Revisions	
Project	
BEDFORD PASSAGE DEVELOPMENT

HARD LANDSCAPE DETAILS - SHEET 02

Drawing No.	Revision
BPD-HLM-00-XX-DR-L-30402	C12

(D25) BENCH TYPE B1a-h 1:20

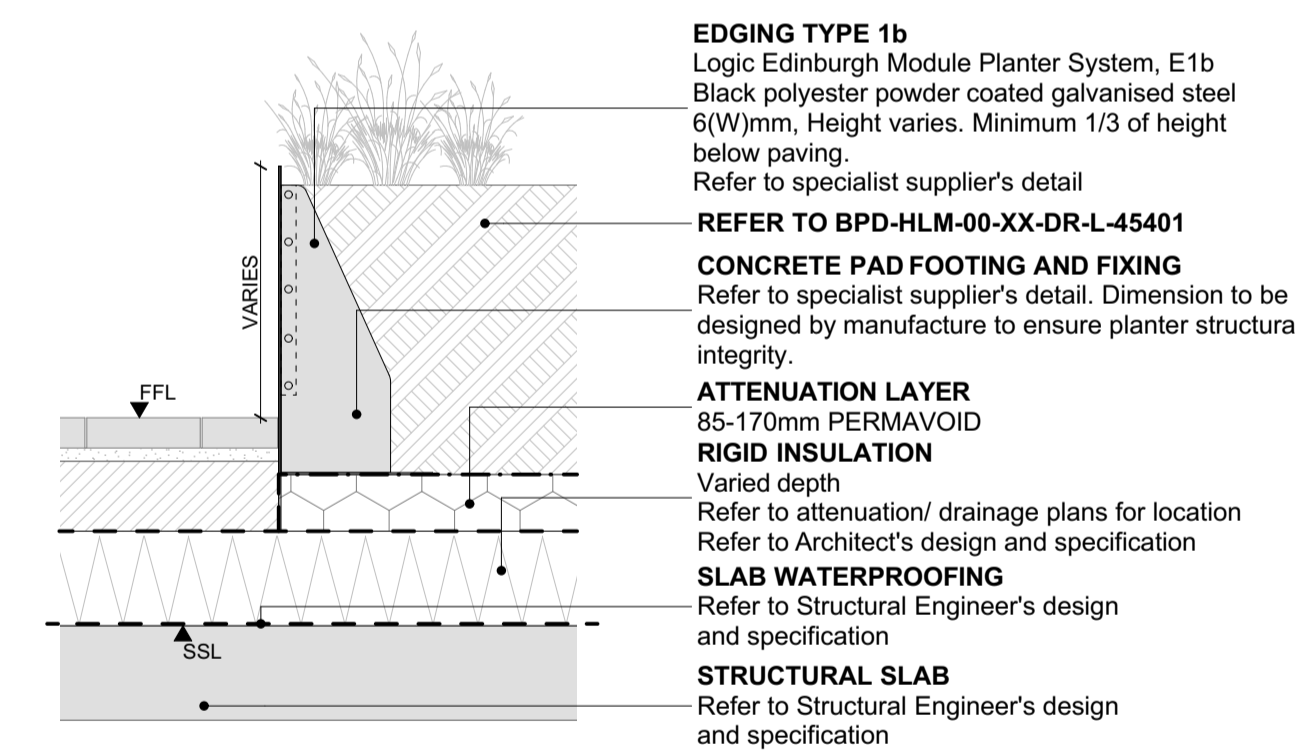
Bench types updated, those not in scope omitted

(D45C) EDGE TYPE 1b STEPS 1:20

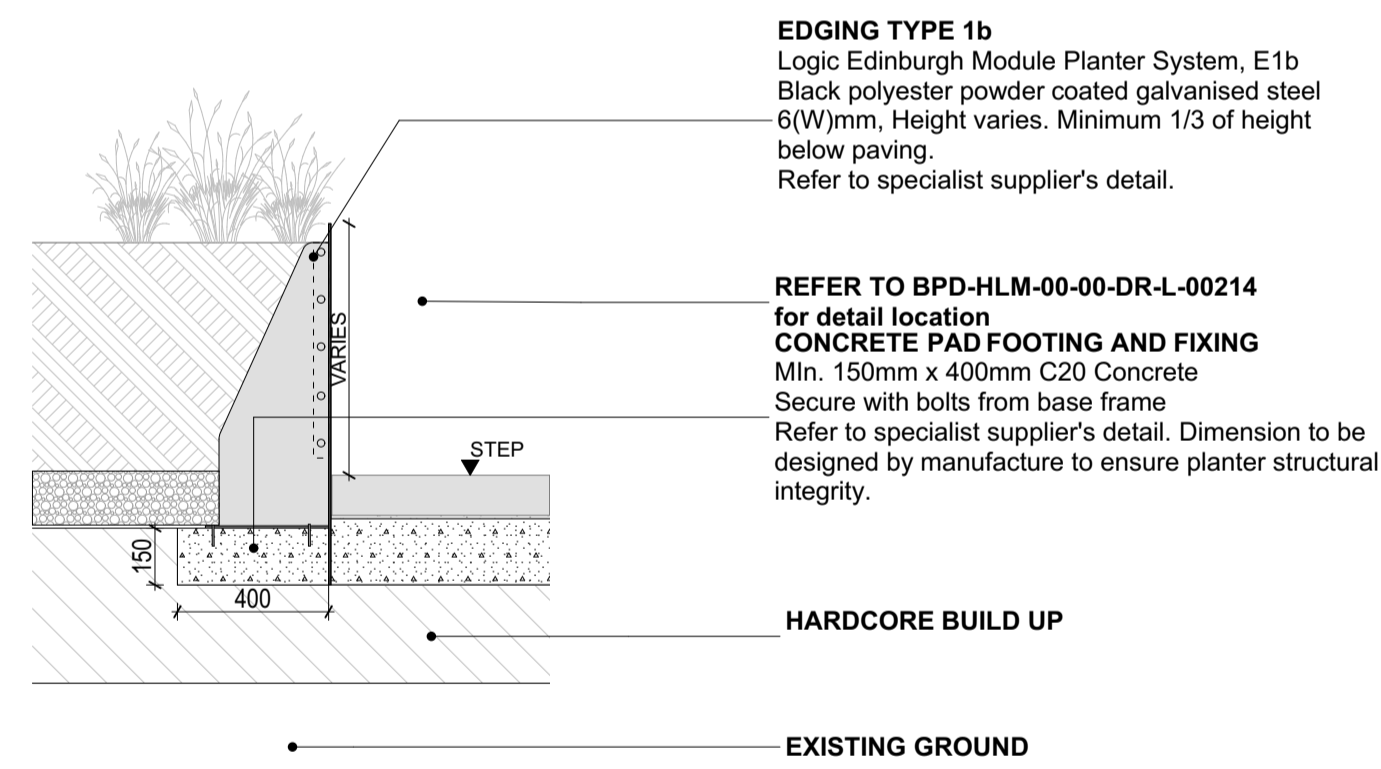
Detail D45, D45A - 1a, Omitted as not in scope
Detail D45 C 1b planter detail to northouse steps added
